3/4.1 REACTIVITY CONTROL SYSTEMS

9705160011
PDR ADOCK 05000423
PDR

INSERT FOR PTSCR # 3-15-97

Pages 3/4 1-3 and 8 (Revised), Figures 3.1-1 to 3.1-5 (Revised) and Specification 3/4 3.5 (Added)

FIGURE 3.1-4
REQUIRED SHUTDOWN MARGIN FOR MODE 5 WITH RCS LOOPS FILLED

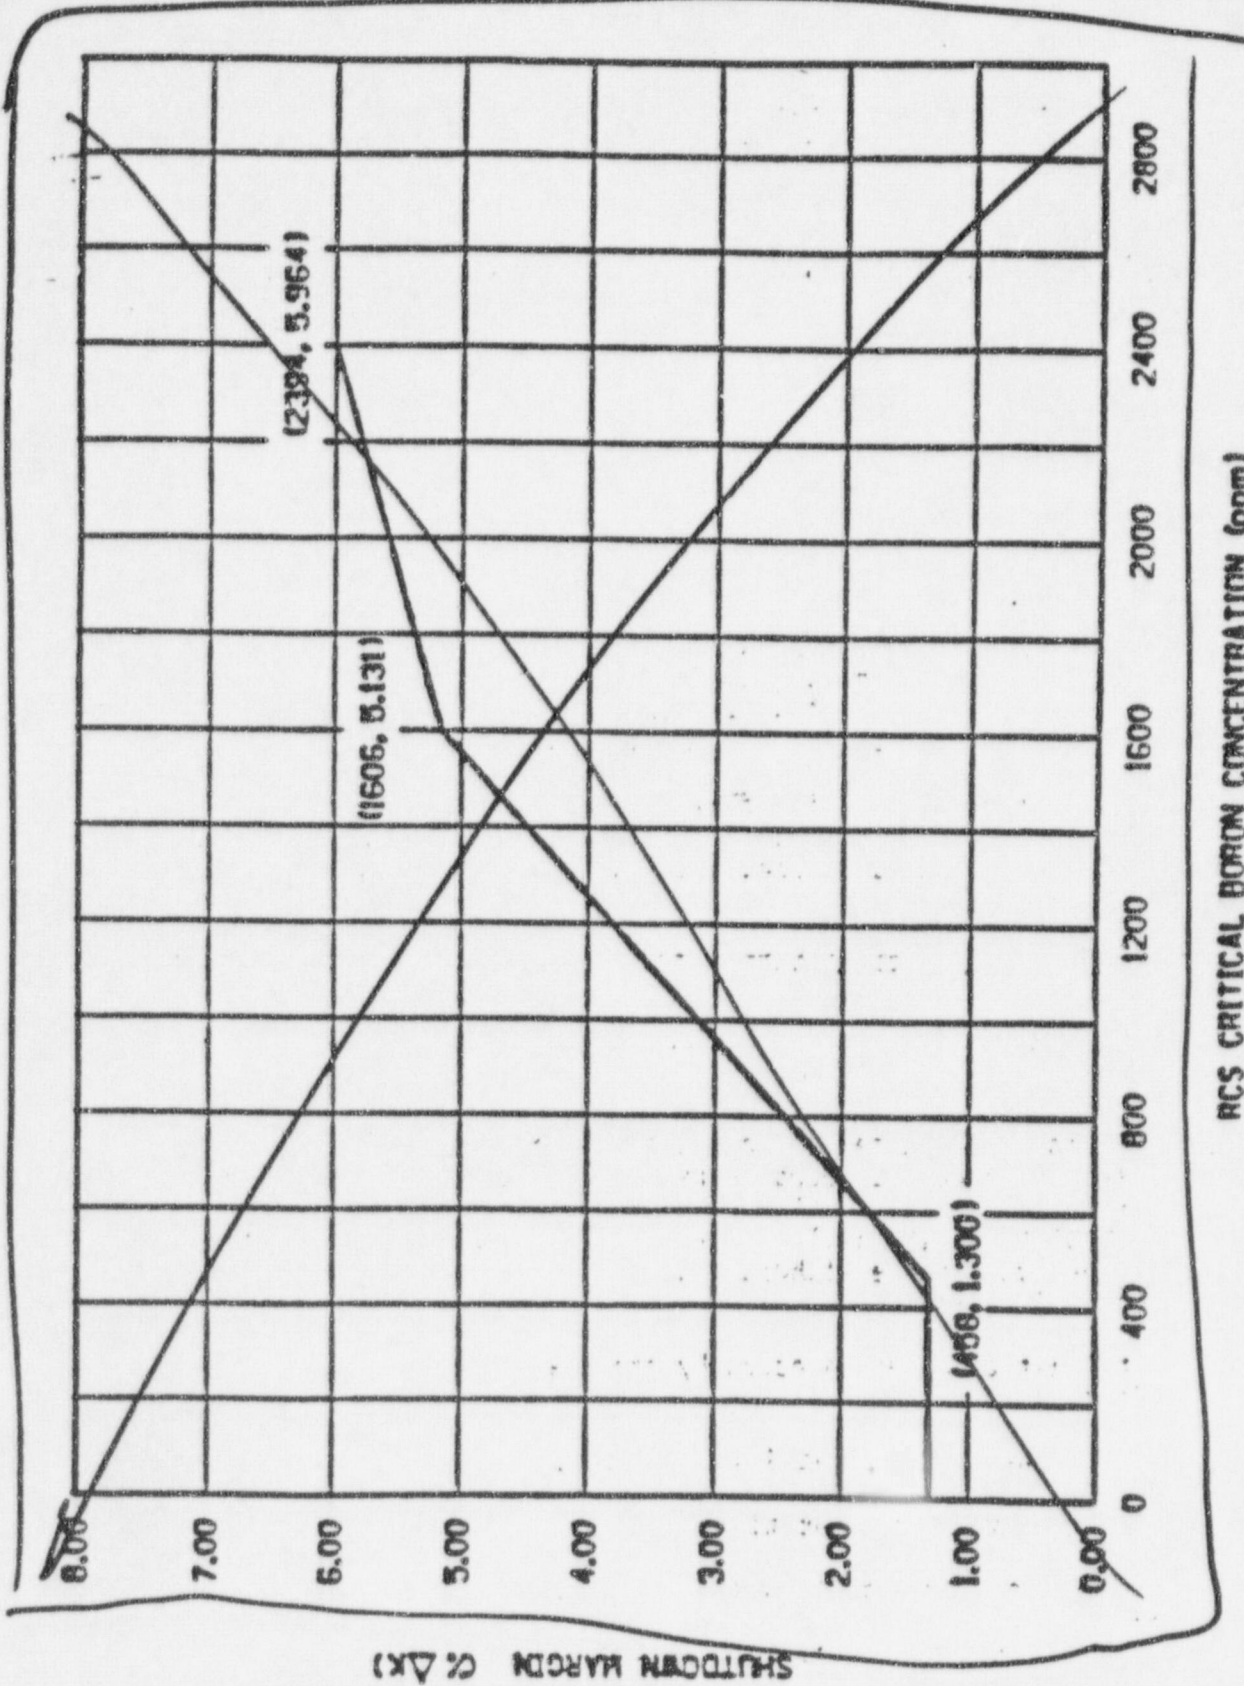
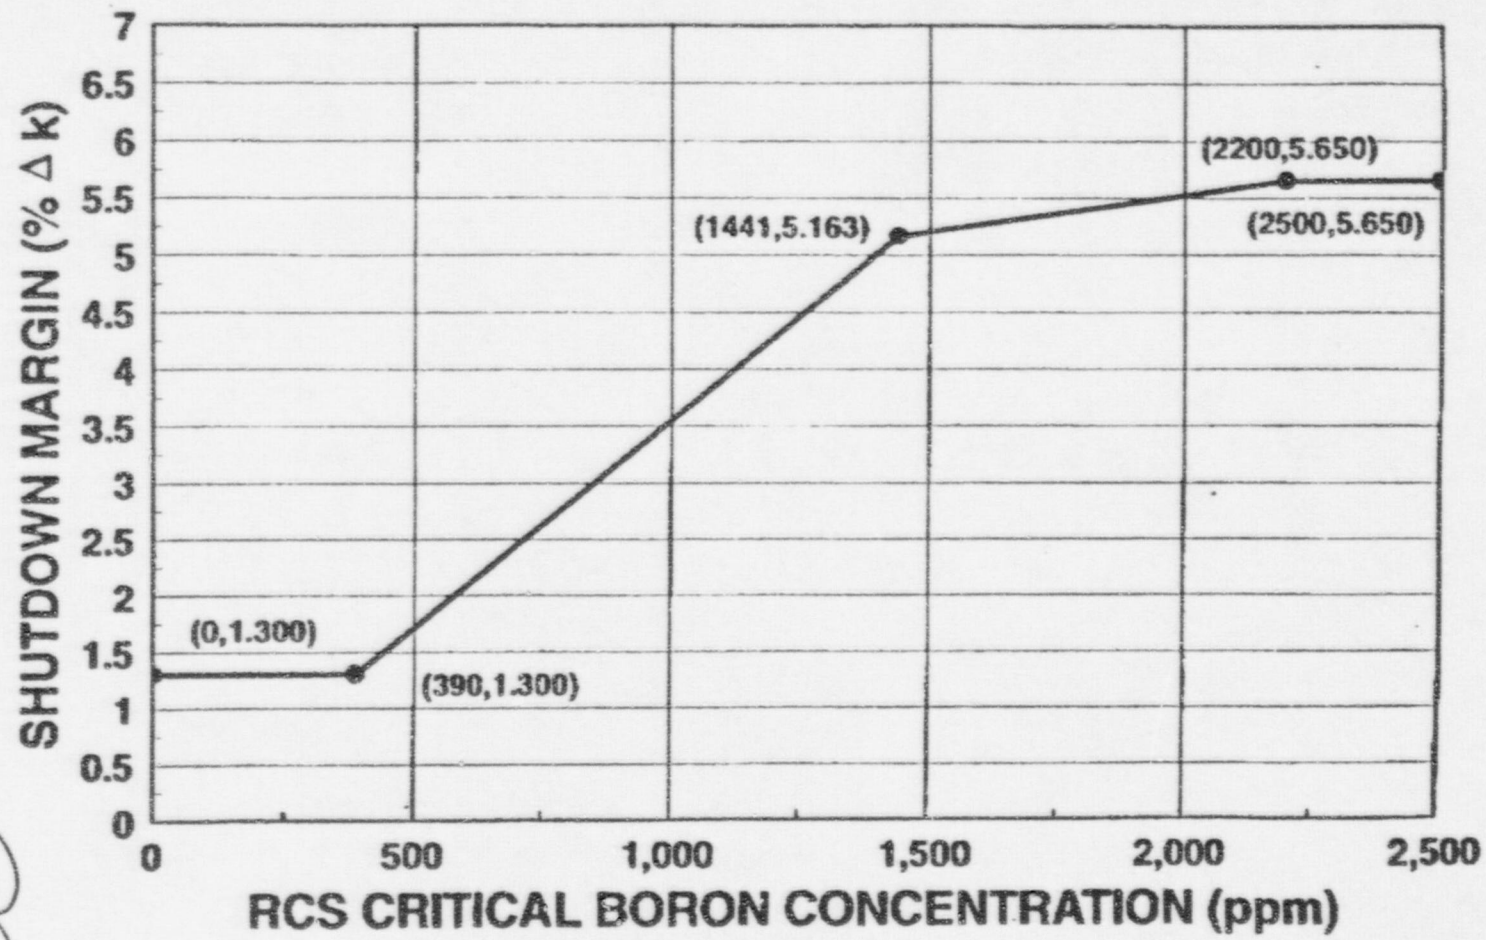
DELETED AND REPLACED BY INSERT 3.1-4

ppm for Mode 3 (to be added to the requirement in Figure 3.1-1 and 3.1-2) and 350 ppm for Modes 4 and 5 (to be added to the requirement in Figures 3.1-3, 3.1-4 and 3.1-5).

- More limiting Shutdown Margin requirements in Figures 3.1-1 to 3.1-5 are added which allow for the SMM to be considered operable for lower count rates in Modes 3, 4 and 5.
- Additional boration values included in Specification 3.3.5 which are to be applied to the Shutdown Margin requirements in Figures 3.1-1 to 3.1-5. The addition of Shutdown Margin above the requirements in the Figures allows the SMM to be considered operable for count rates which are lower than allowed by implementation of only the Figures 3.1-1 to 3.1-3-5 requirements.

FIGURE 3.1-5
REQUIRED SHUTDOWN MARGIN FOR MODE 5 WITH RCS LOOPS DRAINED

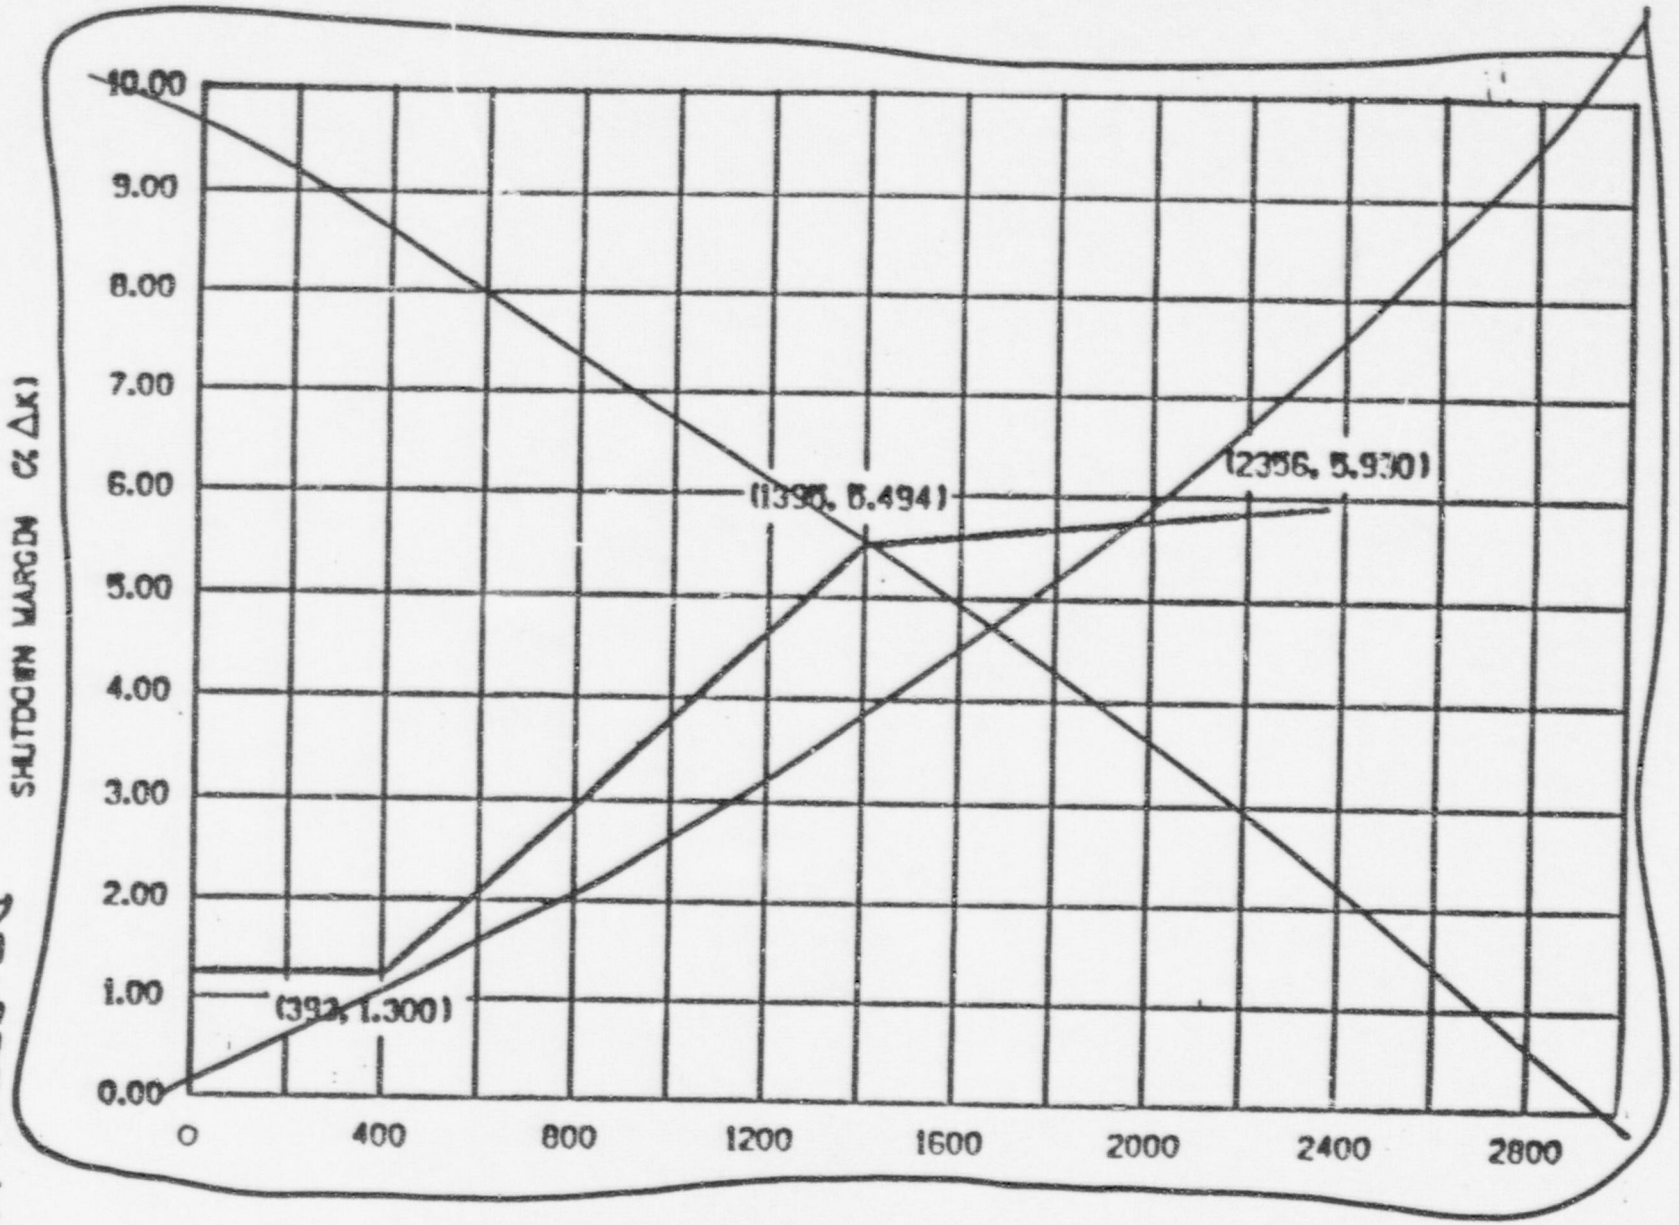
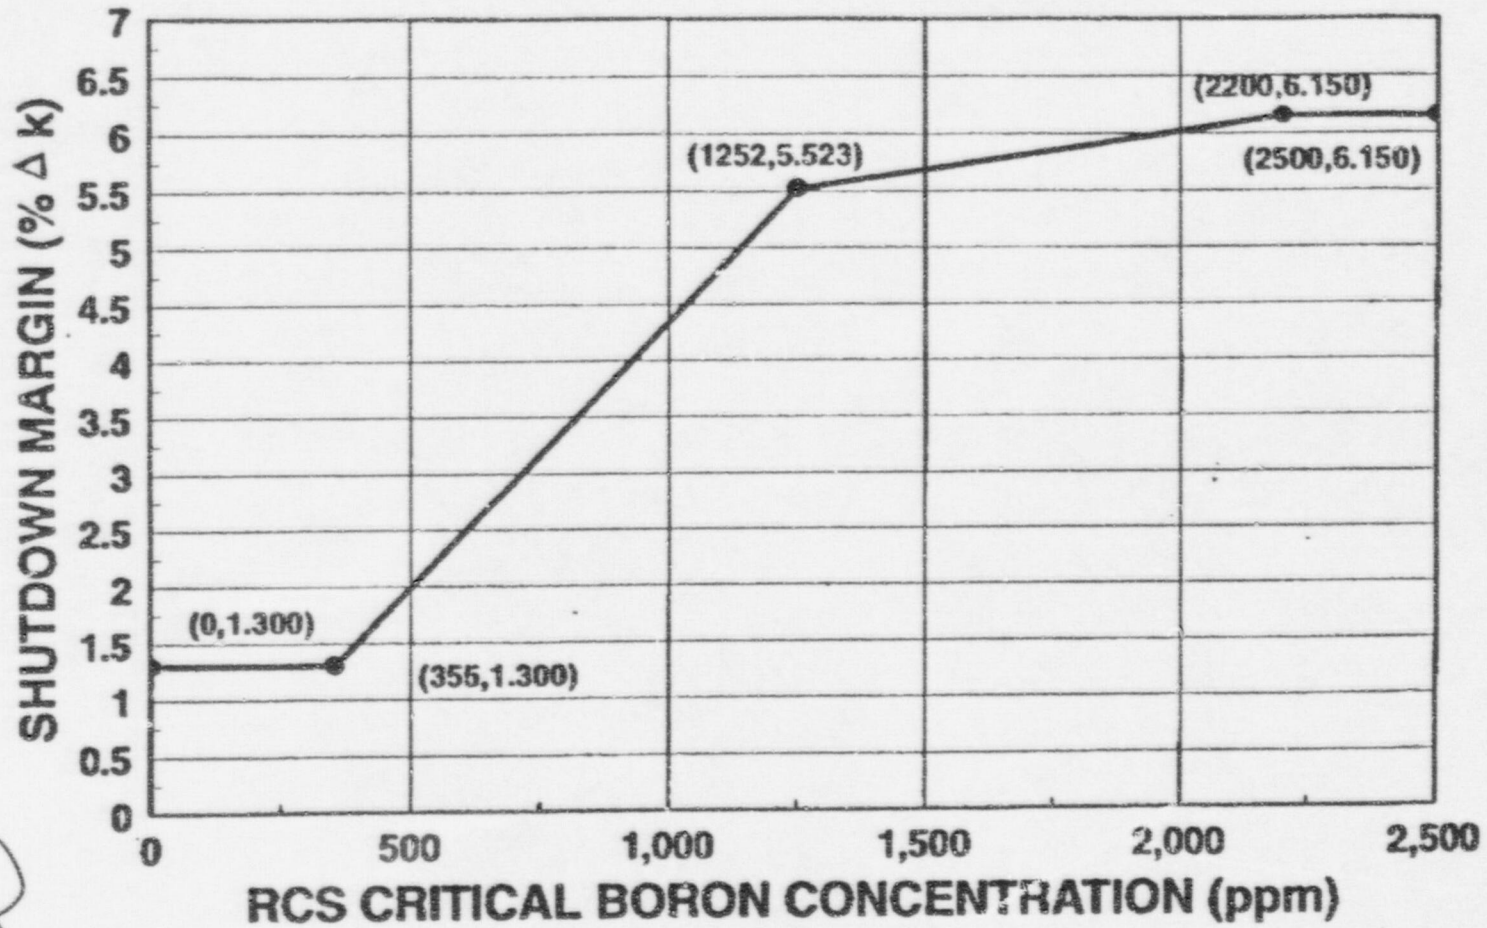
DELETED AND
REPLACED BY
